ECN/PCN No.: 3466

Product Description: Precision SMD TCXO		Abracon Part Number / Part Series: AST3TQ	<input checked="" type="checkbox"/> Series
Affected Revision: C		New Revision: D	<input type="checkbox"/> Part Number
		Application	<input type="checkbox"/> Safety
			<input checked="" type="checkbox"/> Non-Safety

- Mechanical Dimensions & Recommended Land Pattern

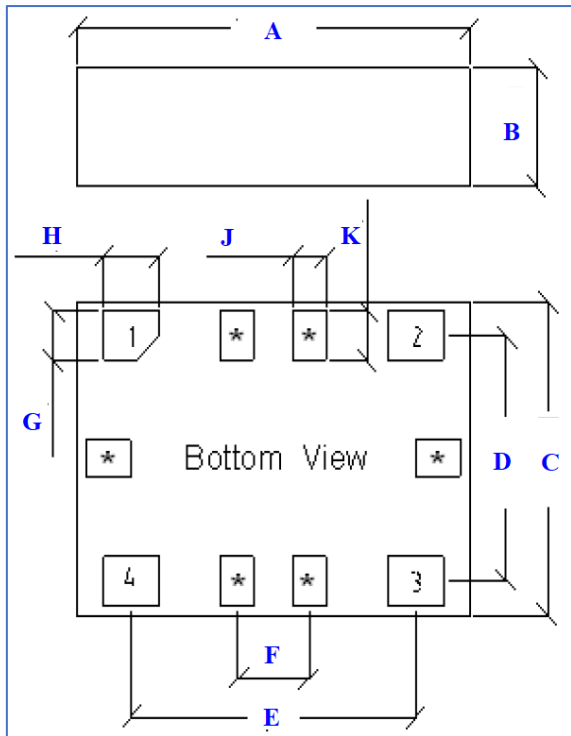
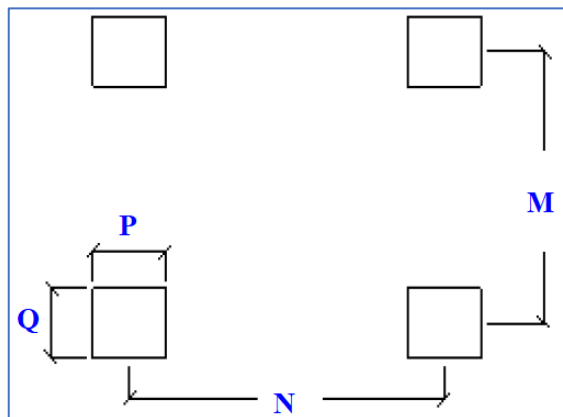
Prior to Change:

Letter	Dimension (mm)
A	7.0±0.1
B	1.9±0.1
C	5.0±0.1
D	3.90
E	5.08
F	1.27
G	4-0.8
H	4-1.0
J	6-0.6
K	6-0.8
M	3.90
N	5.08
P	1.00
Q	1.20

1. Mechanical Dimensions & Recommended Land Pattern

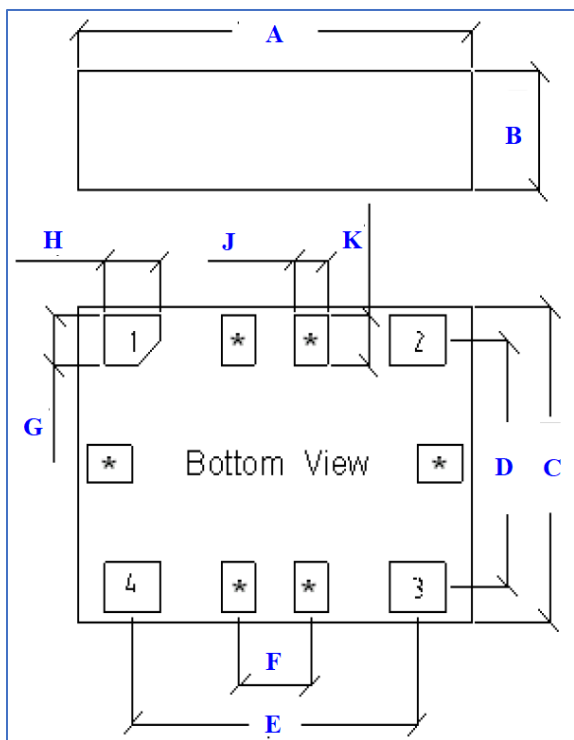
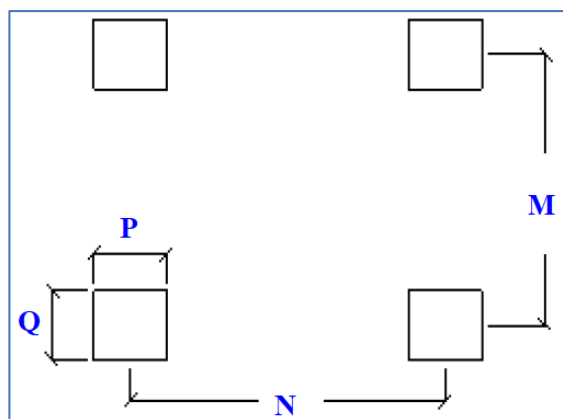
Letter	Dimension (mm)
A	7.1±0.2
B	1.9±0.2
C	5.0±0.2
D	3.90
E	5.08
F	1.27
G	1.00
H	1.50
J	0.60
K	1.00
M	3.90
N	5.08
P	4-1.2
Q	4-1.0

Cause/Reason for Change:		
Electrical <ul style="list-style-type: none"> Standard review and upgrade of Precision SMD VCTCXO product series AST3TQ. The series is now offered at a wider frequency range and select frequencies have improved phase noise performance. In effect, the max current consumption increased by approximately 3mA. Mechanical <ul style="list-style-type: none"> New landing pattern implemented to increase ease of soldering. 		
Change Plan	Effective Date: 9/26/2019	Additional Remarks: All orders placed after 9/26/2019 will exhibit the part changes reflected in this ECN.
Change Declaration:		
Electrical <ul style="list-style-type: none"> The electrical changes to the product series impact the electrical performance of the part. The current consumption increased. Mechanical <ul style="list-style-type: none"> The mechanical changes do not impact the mechanical performance of the part as both the previous & new recommended landing patterns can be utilized for the new package. The new landing pattern was implemented to increase ease of soldering, but it accommodates both packages.
